LAKE NONA URBAN LITE APARTMENTS

SUMMARY

Specific Parcel Master Plan (SPMP) approval for a multi-family development comprised of 279 dwelling units and 503 parking spaces.

Updated: January 23, 2014

DEVELOPMENT PLAN

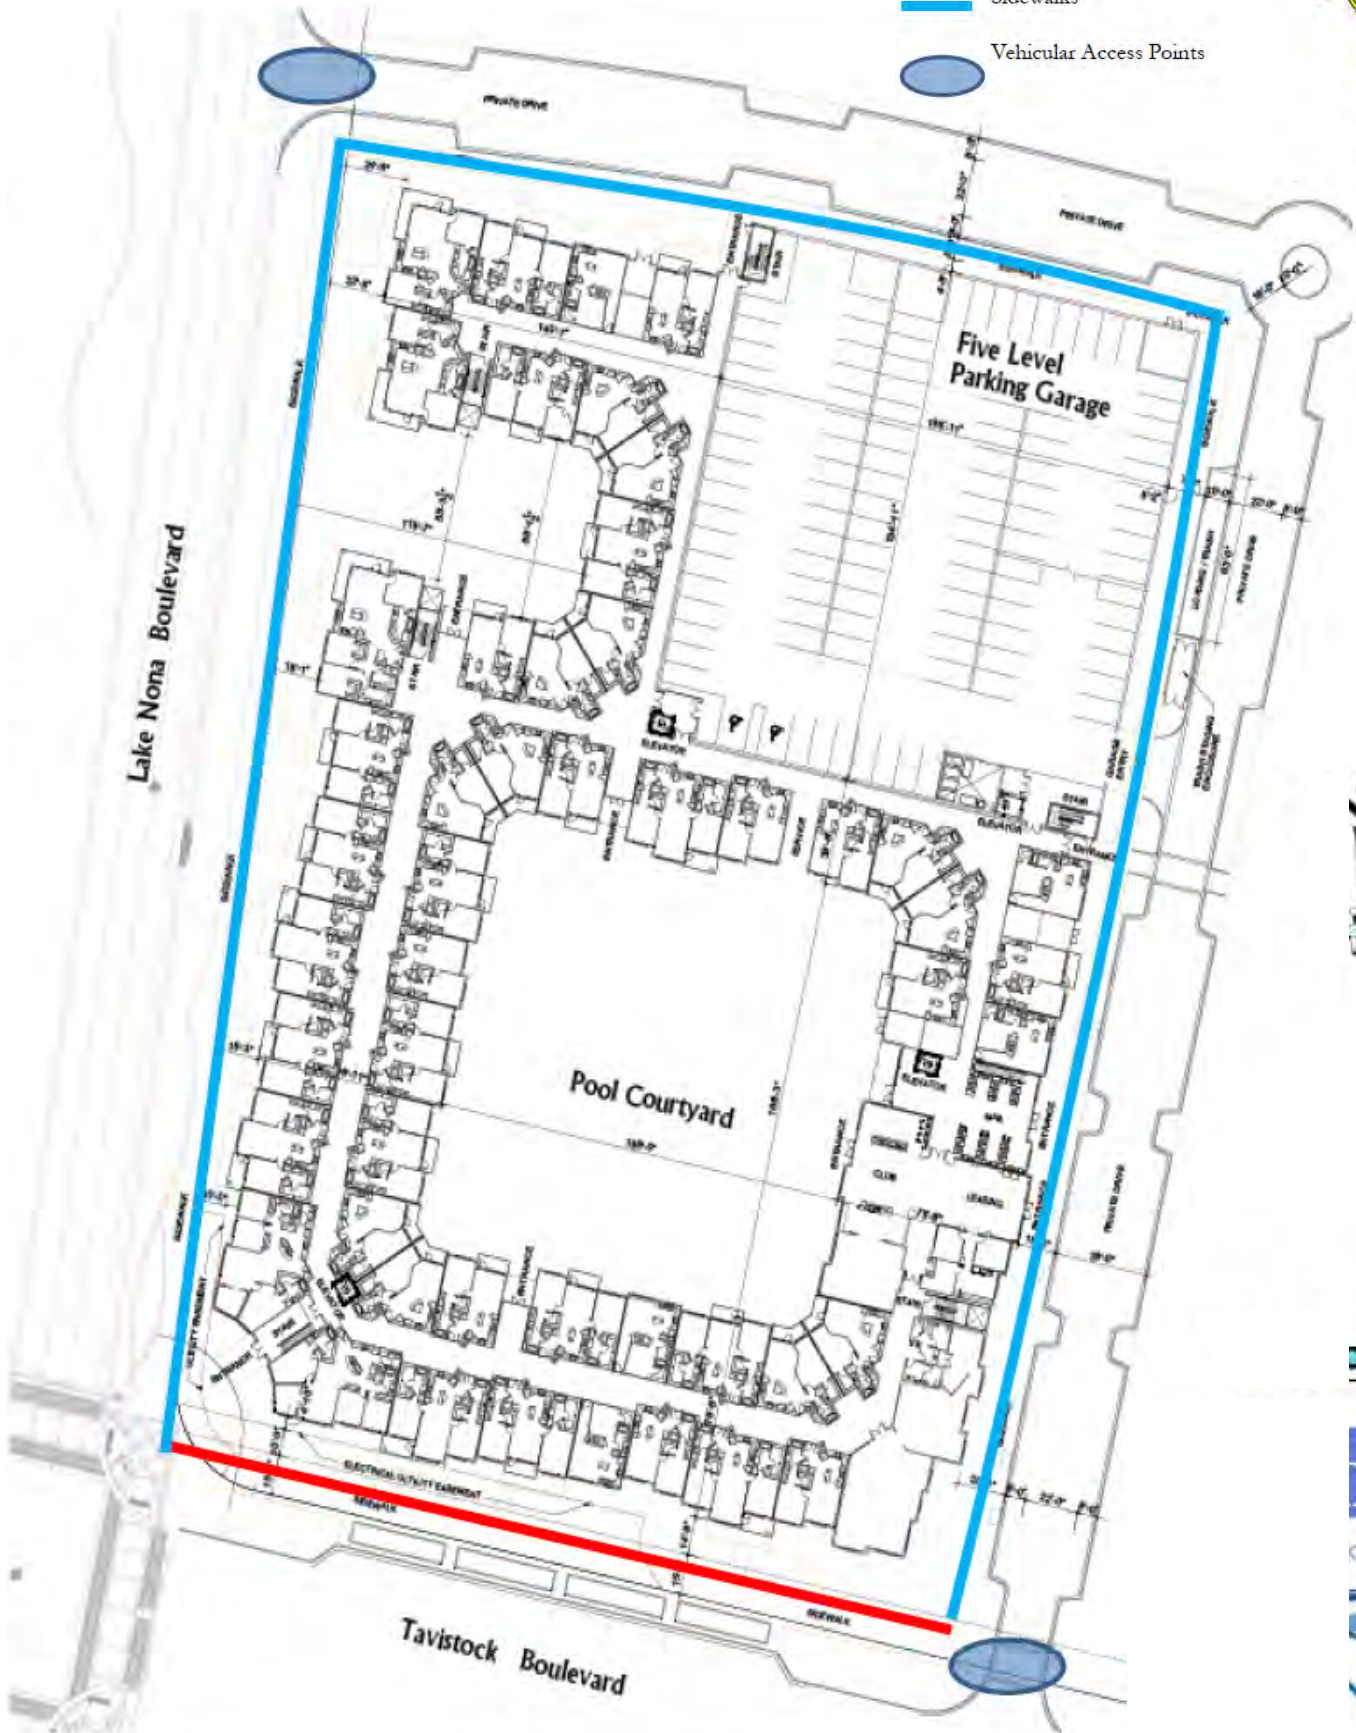
Proposed parallel parking may be too close to intersection. Design spaces to follow FDOT Design Index 17346 minimum on street parking spacing requirements for driver's sight distance.

1. Provide additional entrance/exit for emergency vehicles.
2. Provide additional details on the roundabout including but not limited to radii and an auto turn overlay that shows how waste management and emergency vehicles, utilizing the roundabout, can access the site.
